8801 GLENDALE AVE. N.E.

GRADING AS-BUILT

CALCULATIONS AND DETAILS

I, **Mark H. Burak, P.E.**, NMPE 10987, of the FIRM **Burak Consulting**, HEREBY CERTIFY THAT THIS PROJECT HAS BEEN GRADED AND WILL DRAIN IN SUBSTANTIAL COMPLIANCE WITH AND IN ACCORDANCE WITH THE DESIGN INTENT OF THE APPROVED PLAN DATED **October 8th 2013**. THE RECORD INFORMATION EDITED ONTO THE ORIGINAL DESIGN DOCUMENT HAS BEEN OBTAINED BY **Tony Harris**, NMPS **11463** OF THE FIRM **Harris Surveying, Inc.** I FURTHER CERTIFY THAT I HAVE PERSONALLY VISITED THE PROJECT SITE ON **November 18th 2013** AND AM INFORMED BY VISUAL INSPECTION THAT THE SURVEY DATA PROVIDED IS REPRESENTATIVE OF ACTUAL SITE CONDITIONS AND IS TRUE AND CORRECT TO THE BEST OF MY KNOWLEDGE AND BELIEF. THIS CERTIFICATION IS SUBMITTED IN SUPPORT OF A REQUEST FOR **Certificate of Occupancy**.

TYPICAL RETAINING WALL OVER 18"
N.T.S.

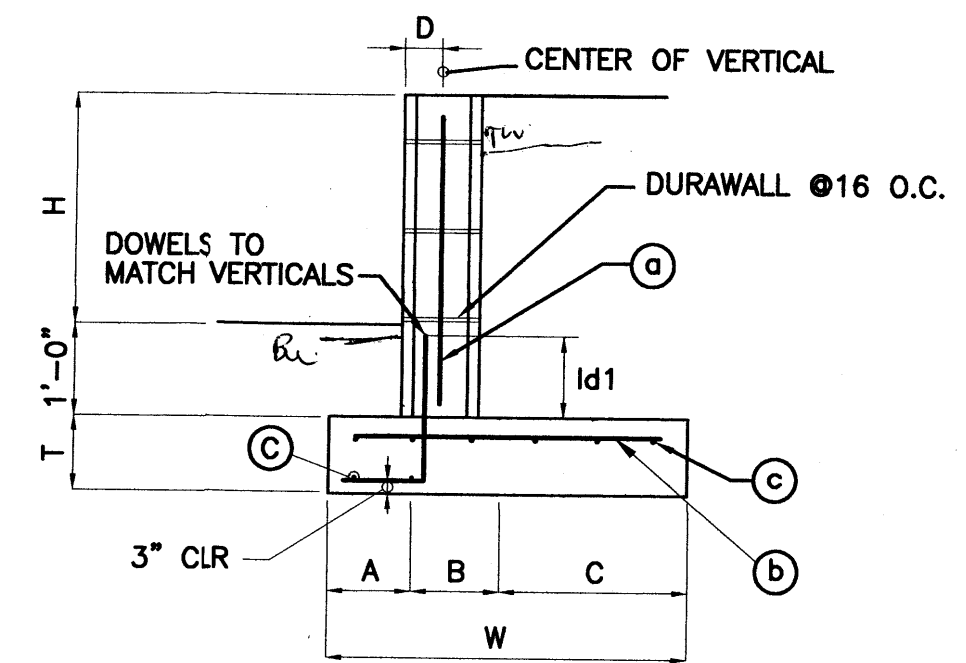
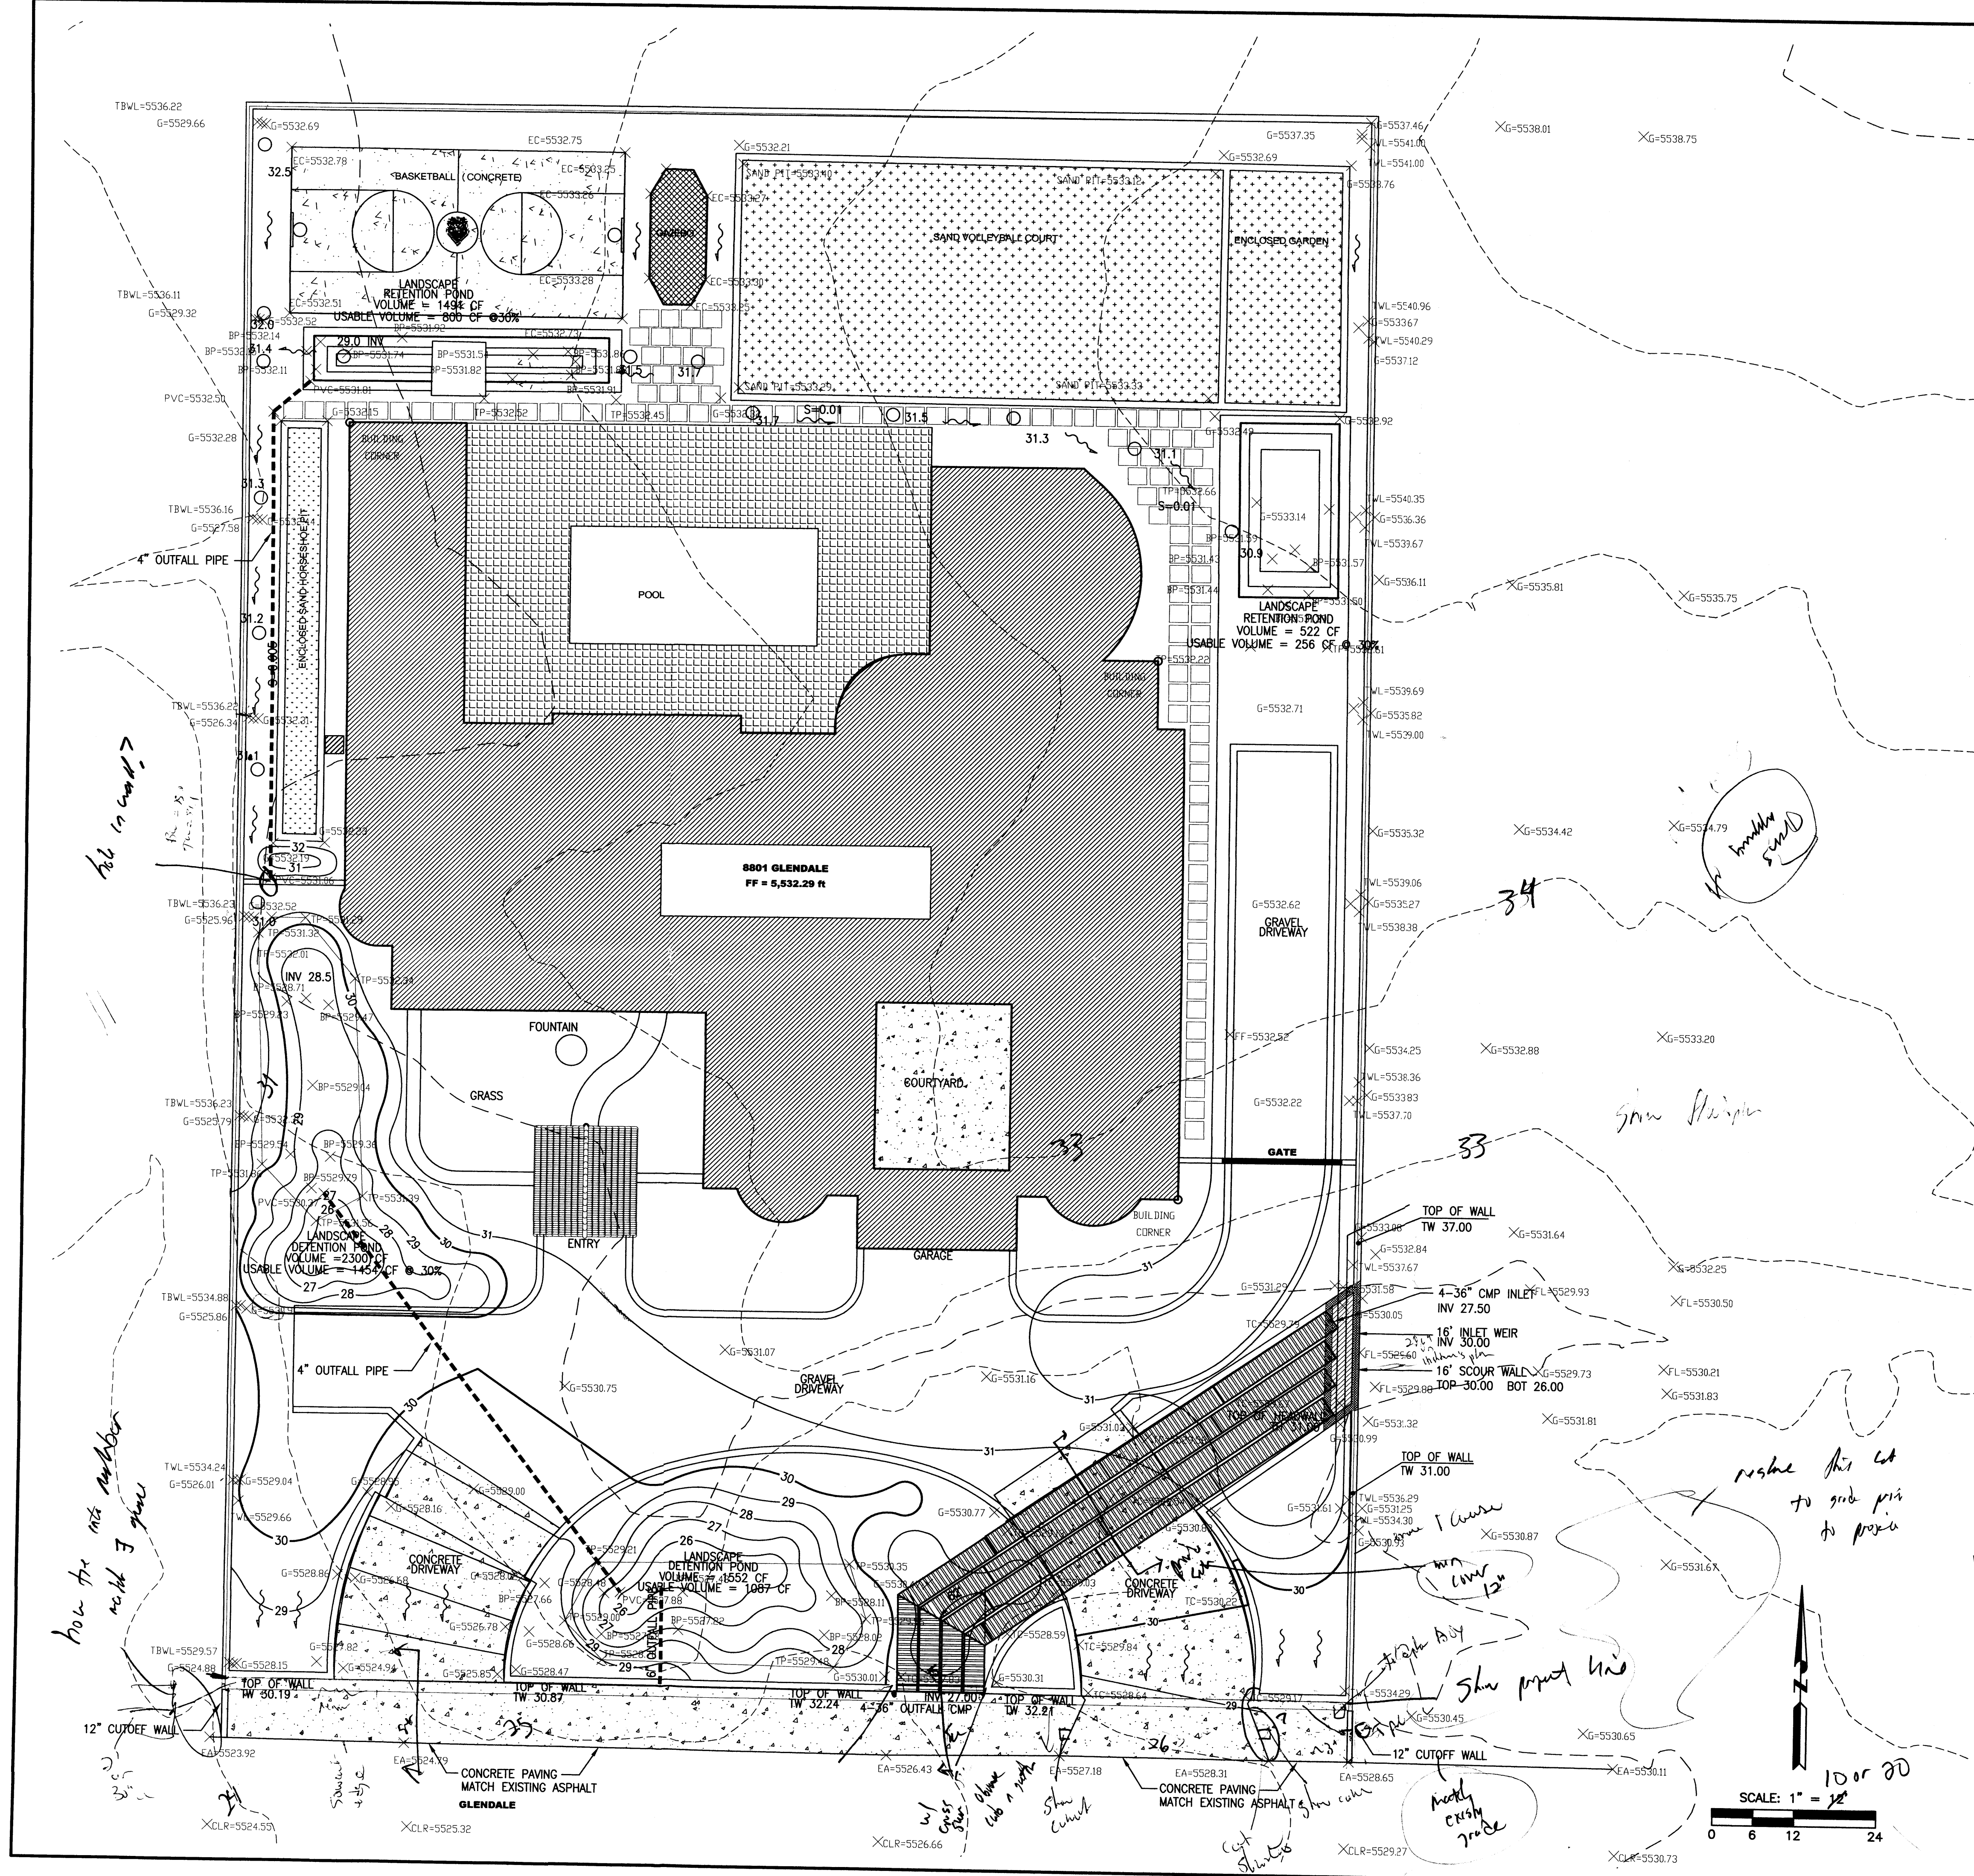
hole in wall?

how far into rubber mat 3' from

note this to give pin to pin

5.75 x 2 = 11.5
2.43 - 1.0 = 1.43 + 1.67 = 2.62

5.75 x 2 = 11.5
1.61 x 2 = 3.22
